SUBJECT: ISSUANCE OF AMENDMENT (TAC NO. 67111)

The Commission has issued the enclosed Amendment No. 85 to Facility Operating License No. DPR-64 for the Indian Point Nuclear Generating Unit No. 3. The amendment consists of changes to the Technical Specifications in response to your application transmitted by letter dated February 5, 1988.

INDIAN POINT NUCLEAR GENERATING UNIT NO. 3

Amendment No. 85  
License No. DPR-64

**FIGURE 6.2-1 MANAGEMENT ORGANIZATION CHART  
POWER AUTHORITY OF THE STATE OF NEW YORK  
INDIAN POINT 3 NUCLEAR POWER PLANT**

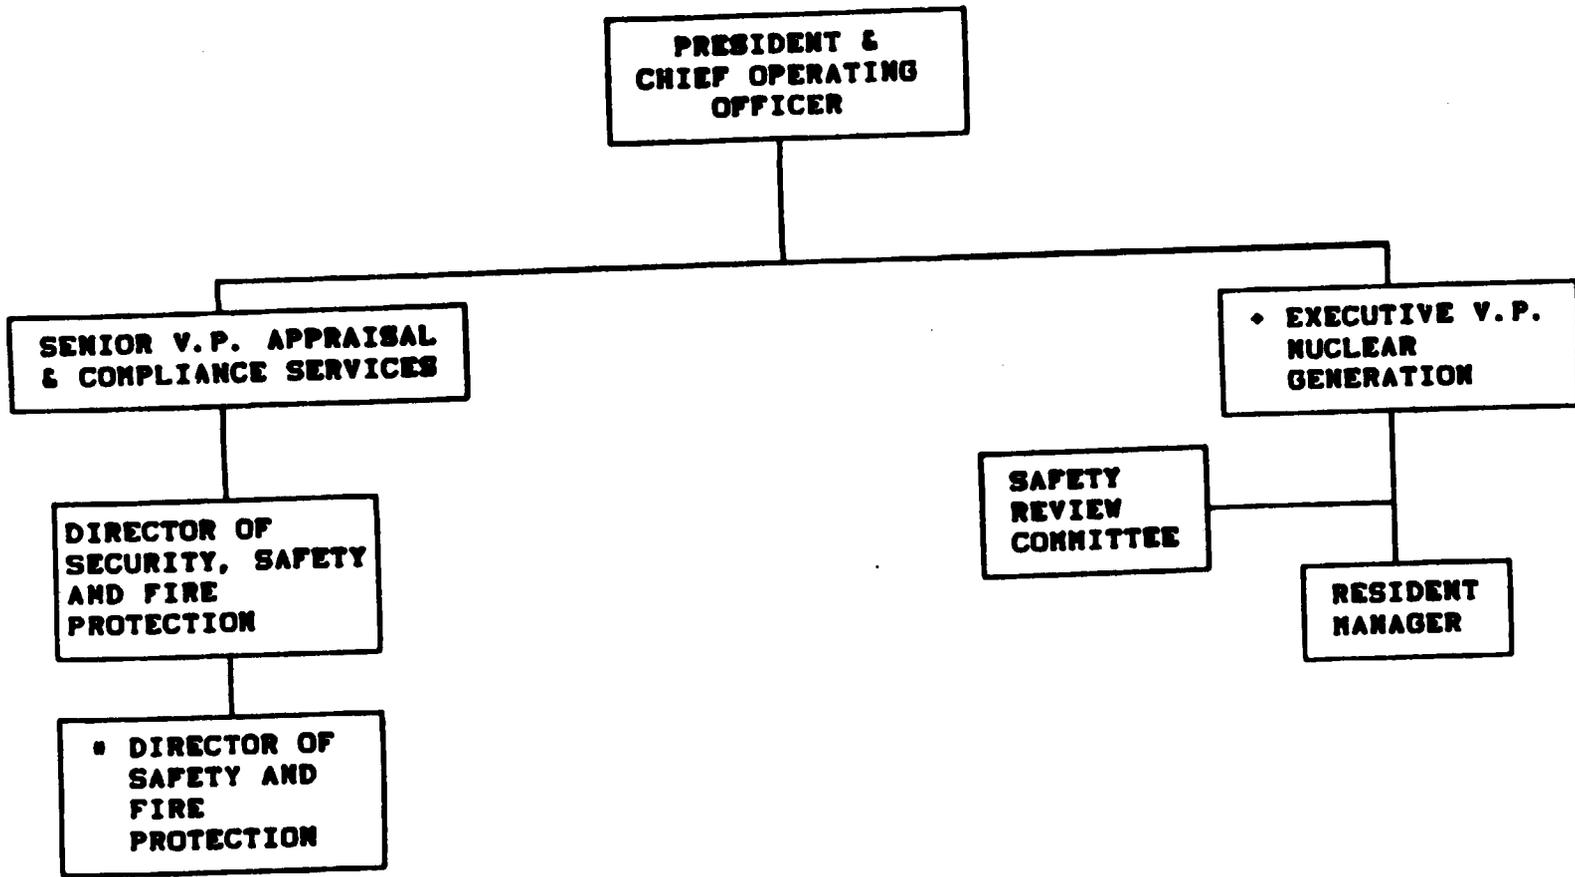
The amendment revises the Technical Specifications to reflect the management reorganization of the Power Authority of the State of New York. The changes affect Figures 6.2-1 and 6.2-2 and Section 6.5.2.2.

The proposed change to TS Figure 6.2-1 reflects elimination of the Engineering and Design Department by deleting the positions of: (1) First Executive Vice President - Operations, and (2) Executive Vice President and Chief Engineer - Engineering and Design. The proposed change to TS Section 6.5.2.2 removes the Vice President - Design and Analysis from membership on the Safety Review Committee (SRC) since the position will no longer exist.

The Engineering and Design Department was divided into nuclear and non-nuclear analytical engineering and design groups and the support staff personnel were reassigned to the Nuclear Generation and System Operations Departments. These changes, therefore, allow the grouping of similar and interdependent activities, affording each of the departments more effective control of the key resources required to accomplish its tasks. The Nuclear Generation Department will now be responsible for all operations, engineering, and construction of the licensee's nuclear power plants. The position of First Executive Vice President - Operations has been eliminated to reduce the number of management levels without compromising effectiveness. However, the responsibility and functions have been divided between the Executive Vice President - Nuclear Generation and Executive Vice President - System Operations.
